Whites Point Quarry & Marine Terminal

REVISED PROJECT DESCRIPTION

**Environmental Assessment/
 Impact Statement
 Comments and Response**

Plan - IR-7

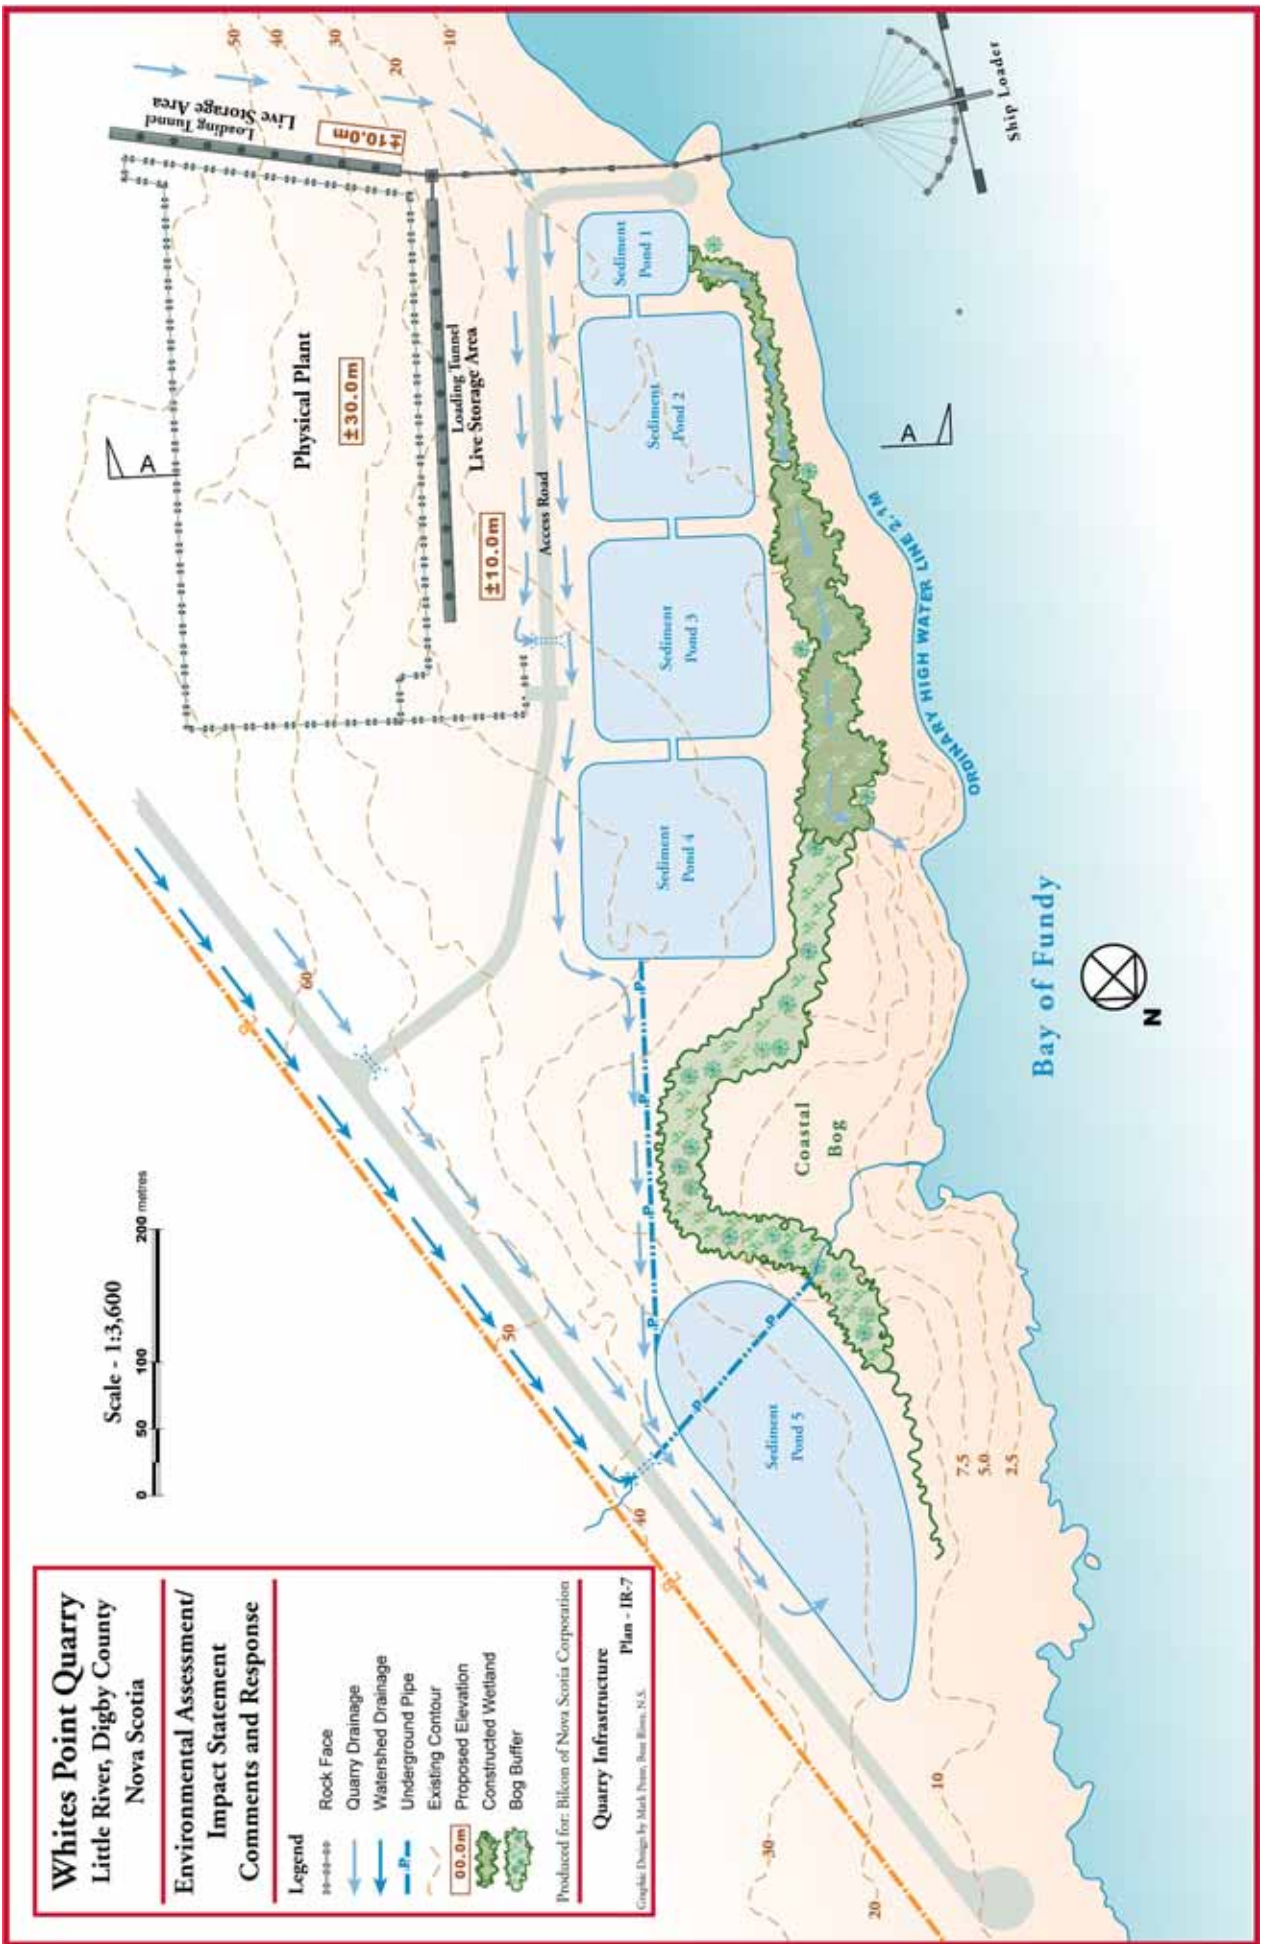
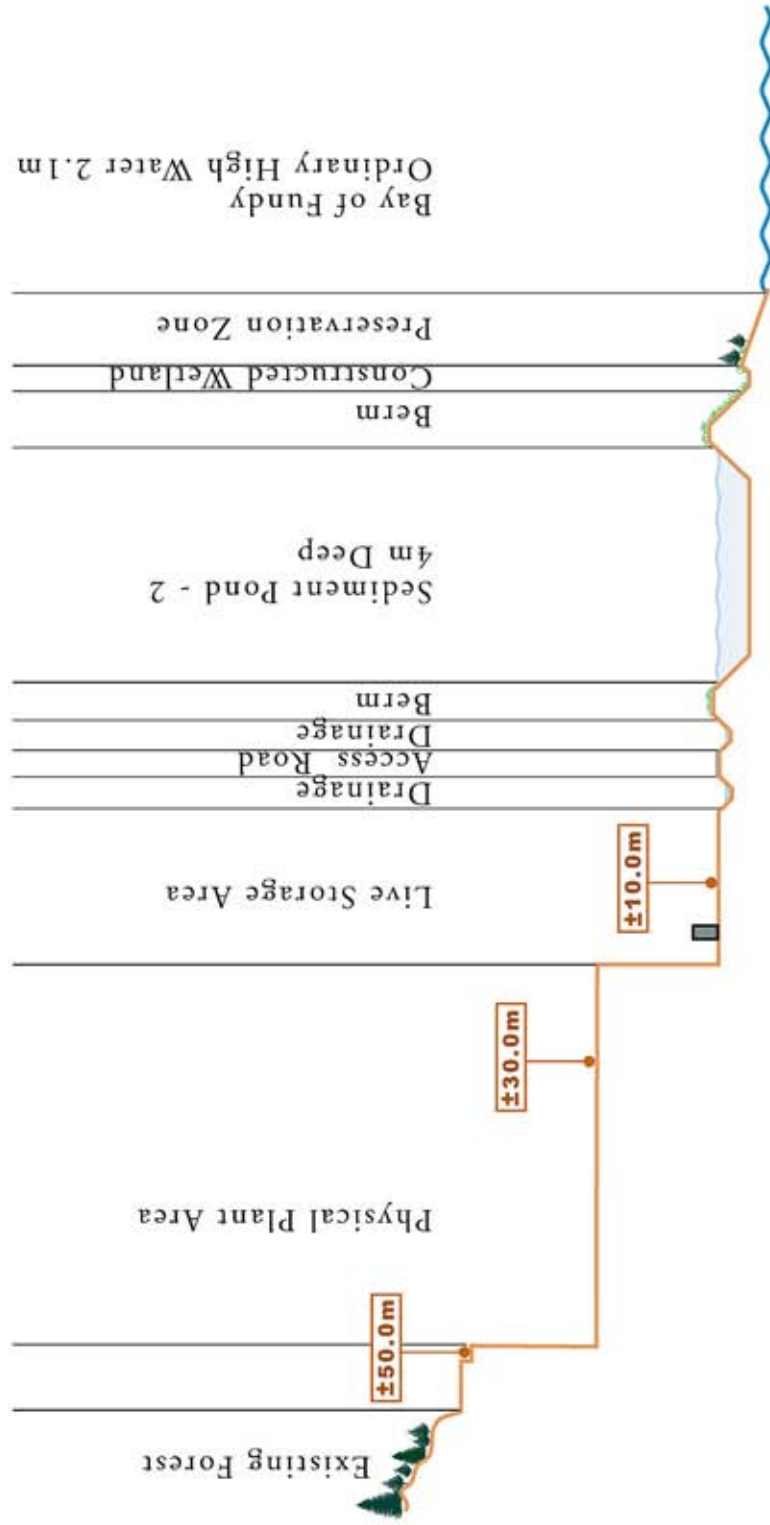
The quarry infrastructure plans (Figure 1) for the EIS and the Fish Habitat Compensation Plan of September 2005 (Appendix 17) differ in how they illustrate critical components. Examples include the footprint of the physical plant, orientation of the loading tunnel, the direction of flow in drainage channels, and the use of the “Phase 1 Reclamation area”.

Figure 5-R1

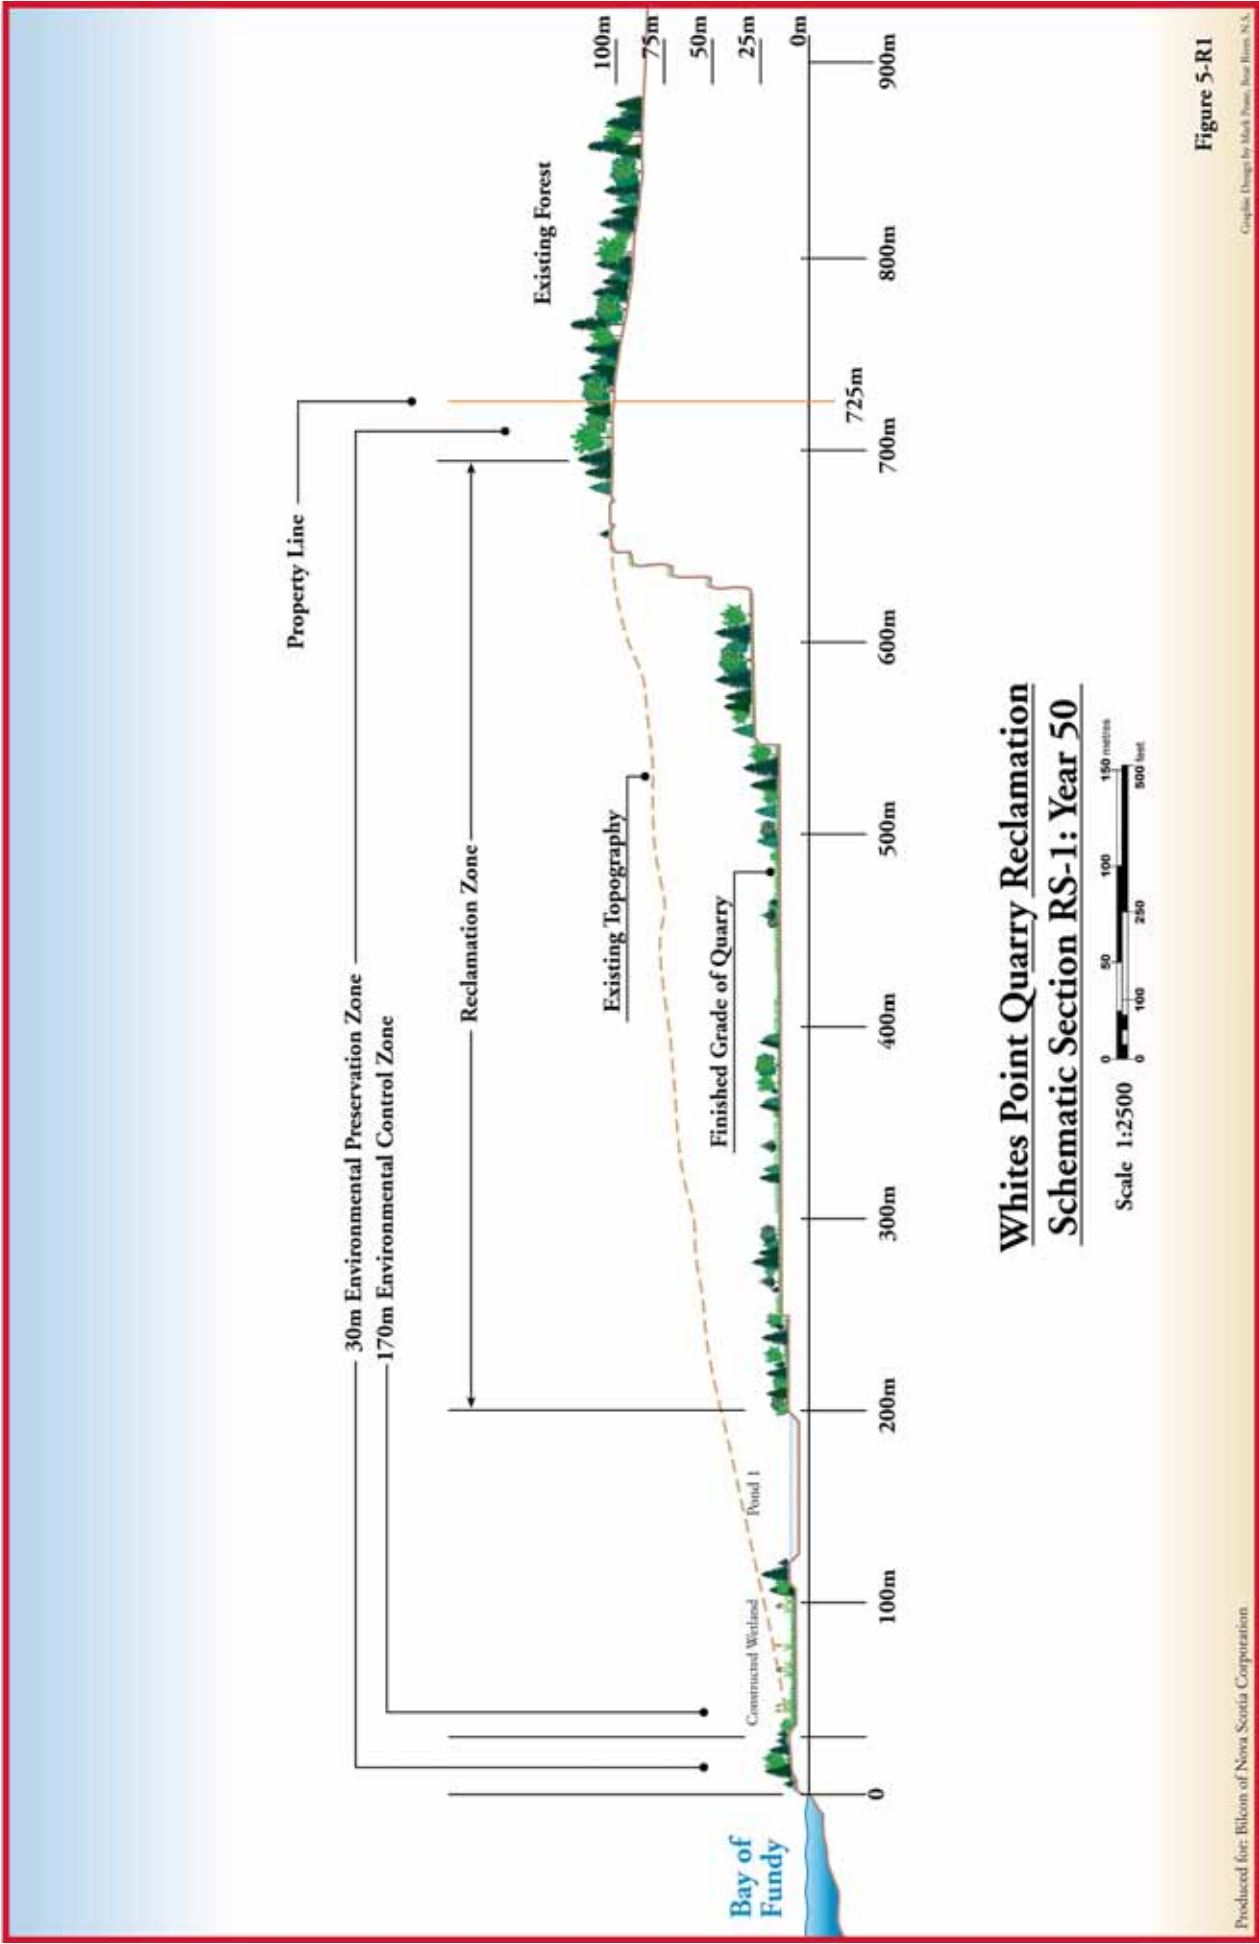
7.9 – Modification - An example of the lack of appropriate mining plans is illustrated by the outline of the quarry boundary shown in Figure 5 of the EIS Chapter 7.9. The height of each of the four benches is approximately 22.5 m, which is about 3 times the height of the bench that is inferred from the proposed Shot 1 (of the blasting plan of 2002, examined in detail later at Deficiency Number 31.). The EIS does not include the design of the benches and geometry of the progressive blasts, which will permit to achieve the boundary of Figure 5 and the planned production of aggregate, in conformance with the provincial and federal guidelines for observing the environmental constraints. No information is provided regarding the standard blasting plan to be used during the 49 years of quarry operations.
